Republic of the Philippines  
**GOVERNMENT PROCUREMENT POLICY BOARD**  
**TECHNICAL SUPPORT OFFICE**

**Project: Procurement of Janitorial Service for the GPPB-TSO New Building**

**Bid Bulletin No.: 01**

**SCHEDULE OF FLOOR FINISHES:**

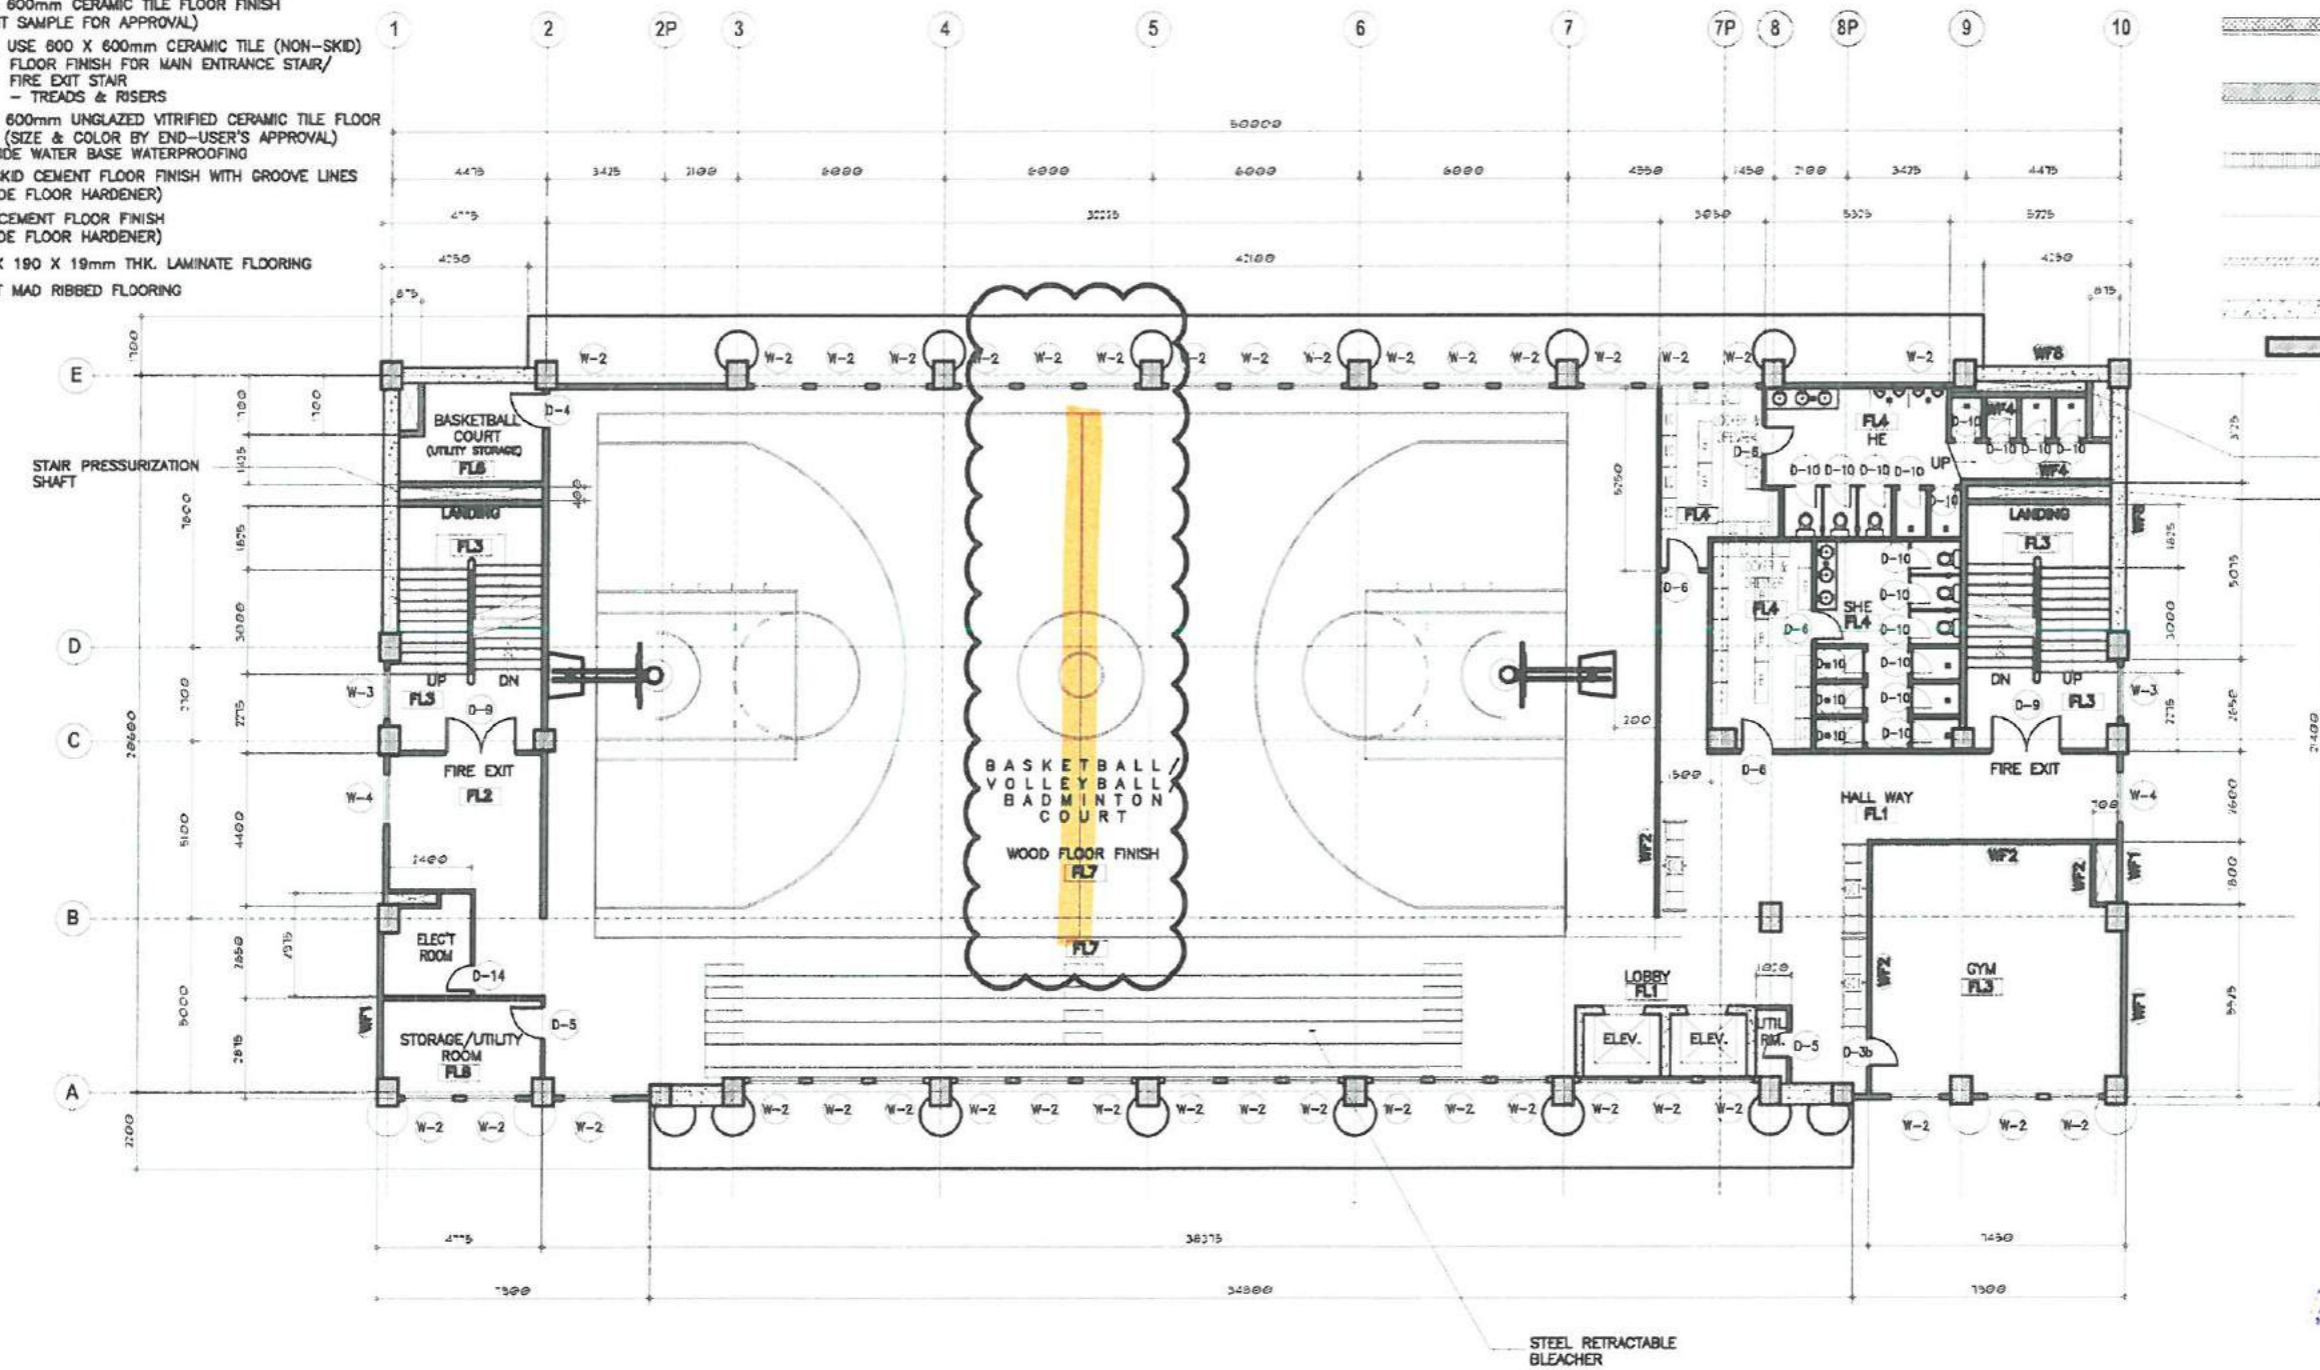
<b>Questions/Concern on the requirements</b>	<b>Clarifications/Answers</b>
1. How many floors are there in the building and how many rooms are there per floor?	There are seven (7) floors in the building and each floor has various number of rooms.  First floor: 12 rooms Second floor: 20 rooms Third floor: 15 rooms Fourth floor: 19 rooms Fifth floor: 16 rooms Sixth floor: 19 rooms Seventh floor: 9 rooms  Please note that enclosed spaces such as storage areas and stairs were counted as rooms. Kindly see attached floor plan reference.
